Staff Report

Re: PLNHLC2015-00930 New Construction PLNHLC2015-00931 Special Exception

NEW CONSTRUCTION – APARTMENT BUILDING

PROPERTY ADDRESS: 454-466 SOUTH TEMPLE PARCEL ID: 1606202008, 1606202009 HISTORIC DISTRICT: South Temple Local Historic District ZONING DISTRICT: H Historic Preservation Overlay District. R-MU (Residential/Mixed Use District) MASTER PLAN: Central Community Master Plan DESIGN GUIDELINES: Multi-Family

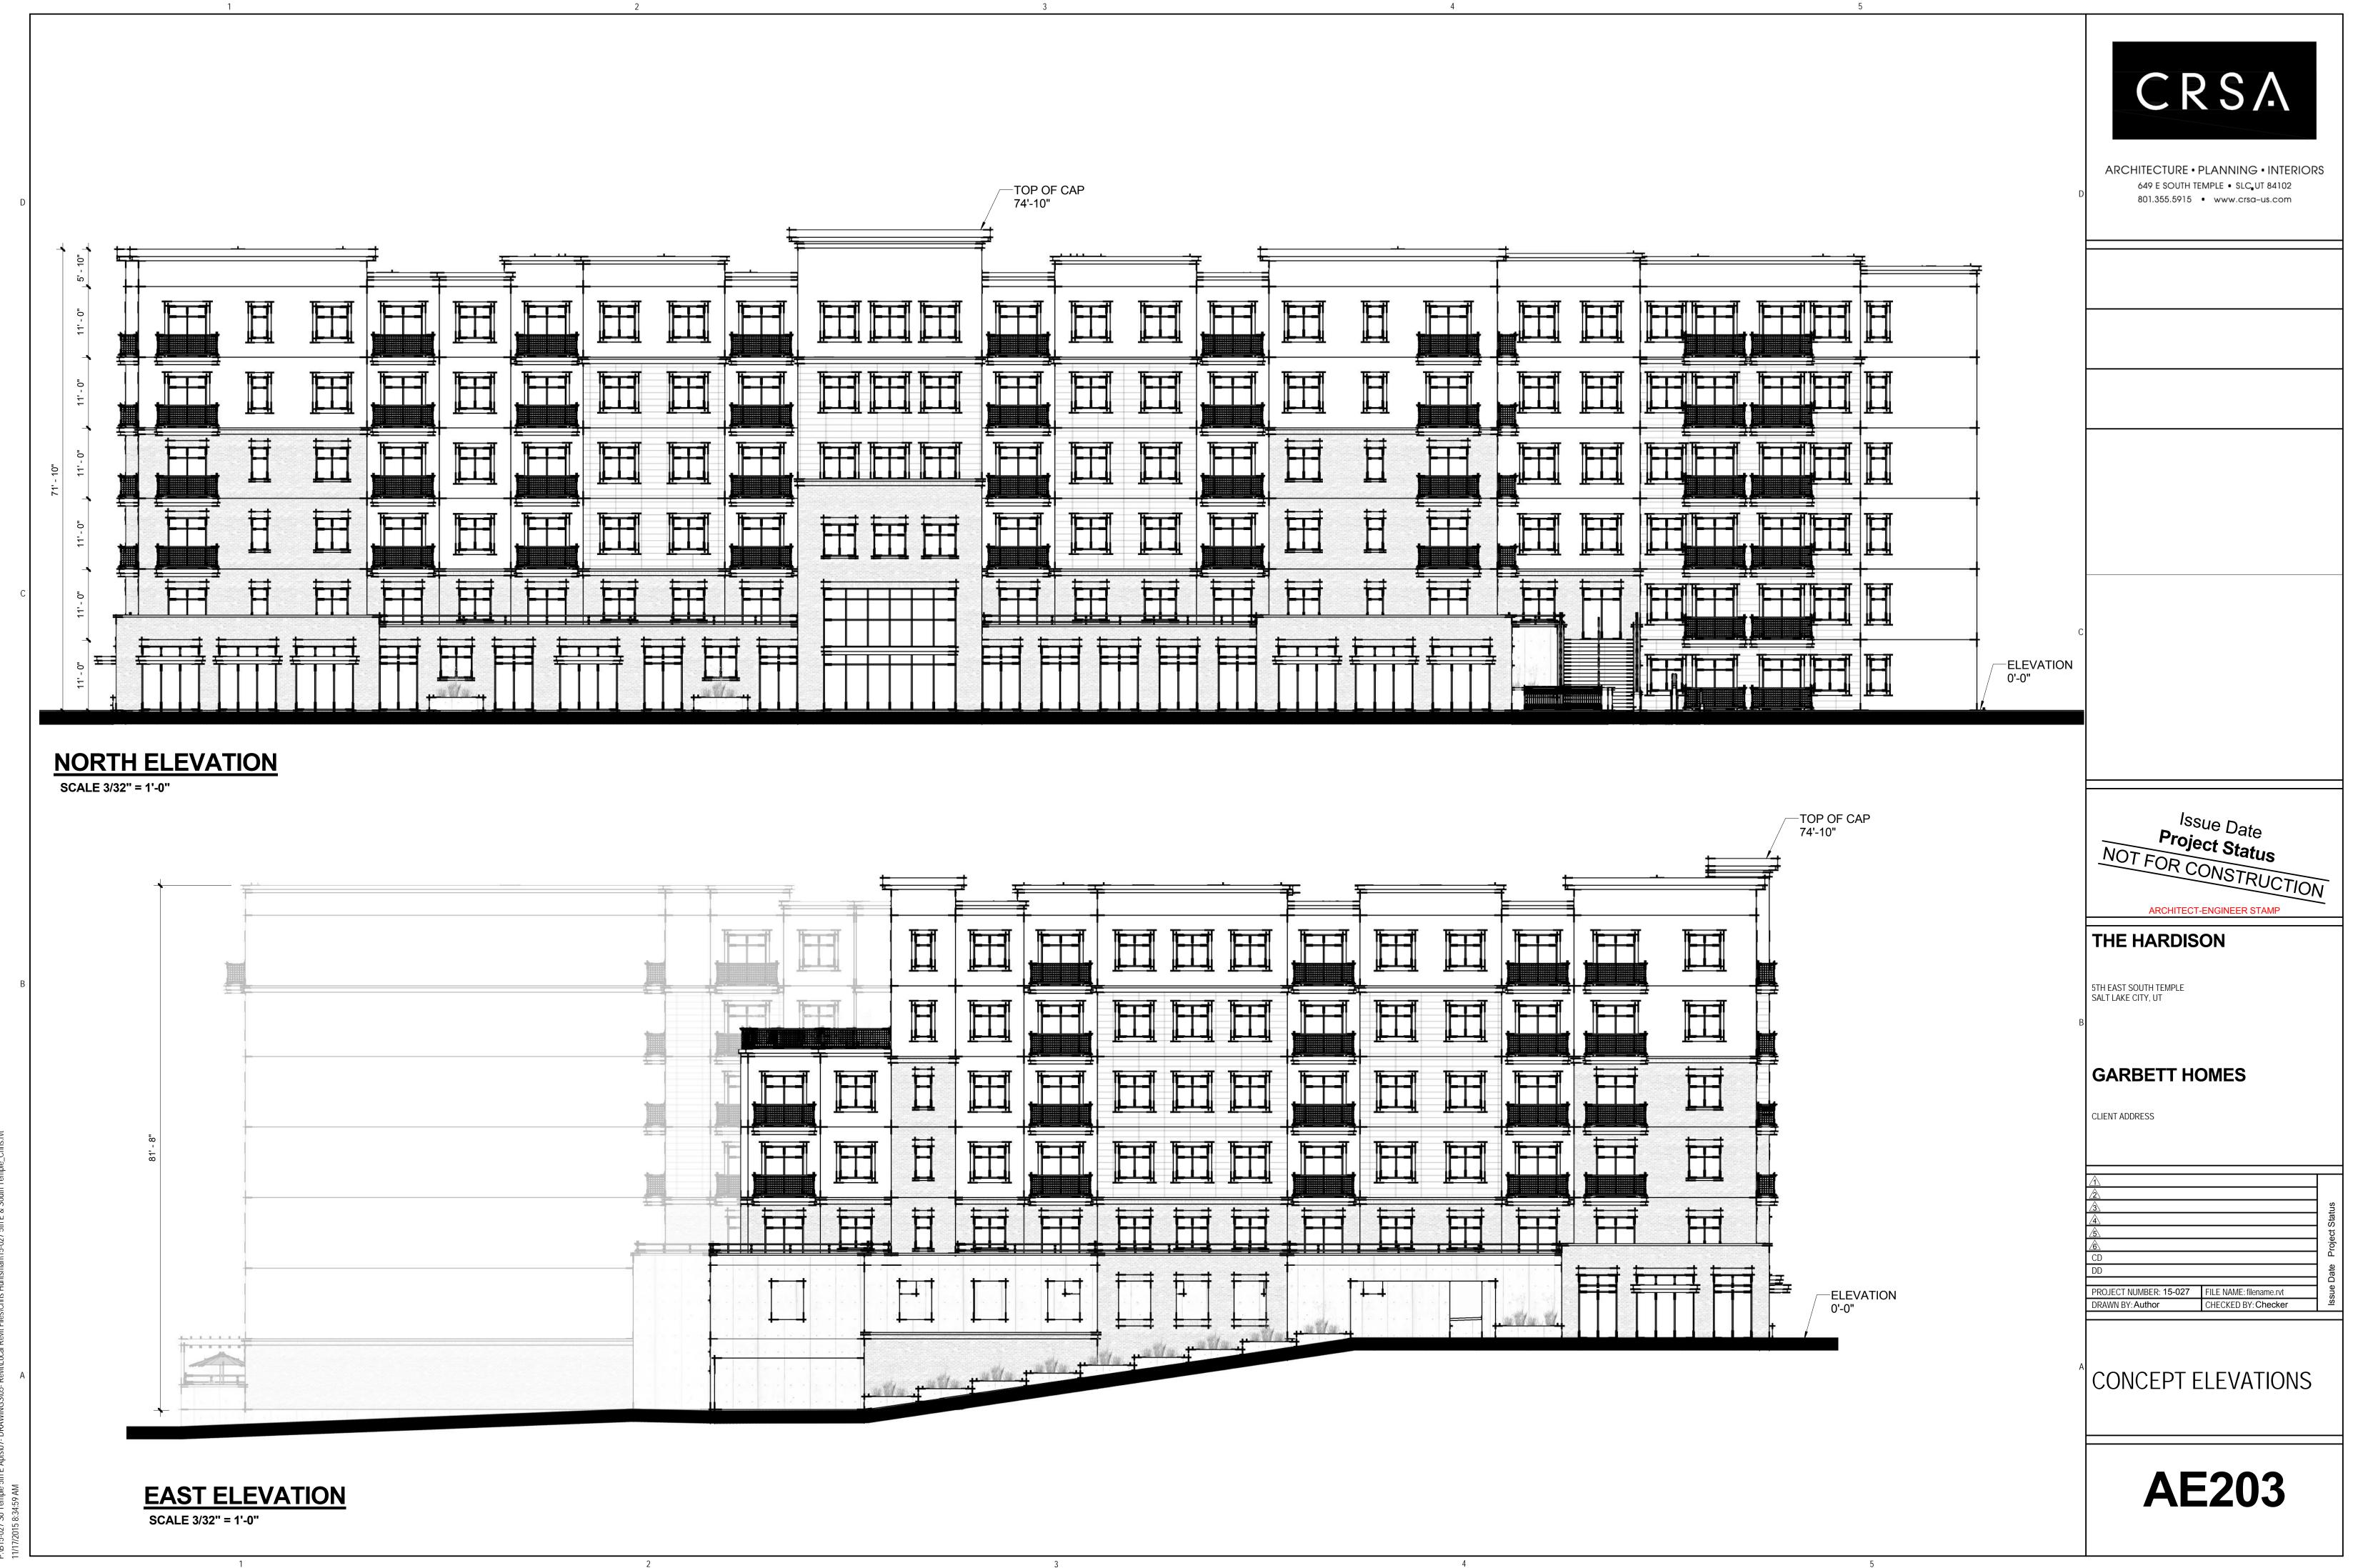
- B. **Special Exception Approval** In order to construct the proposed development as proposed, special exception approval is sought for an encroachment of 20 feet into the required rear yard setback on the west side of the development to accommodate part of the building, two stair ways and an ADA ramp that are greater than 4 feet in height. In conjunction to the encroachment, the applicant is seeking a special exception for approximately 6 feet 8 inches in additional building height for a portion of the west elevation and a portion of the south elevation at the southwest corner of the site. A grade change greater than four feet is also requested in order to accommodate the parking access ramp. Case Number PLNHLC2015-00931

To construct the proposed building the applicant is seeking Special Exception approval for encroachment of approximately 20ft into required rear setbacks towards the SW corner of the site. Two stairways and an ADA ramp are in excess of 4 ft in height within the rear setback. With the reduction in established grade proceeding south across the site, the proposed building would be in excess of the 75' R-MU base zone height ceiling, with height extending to 81' 8" along the south facades, thus approximately 6' 8" in excess of the R-MU maximum
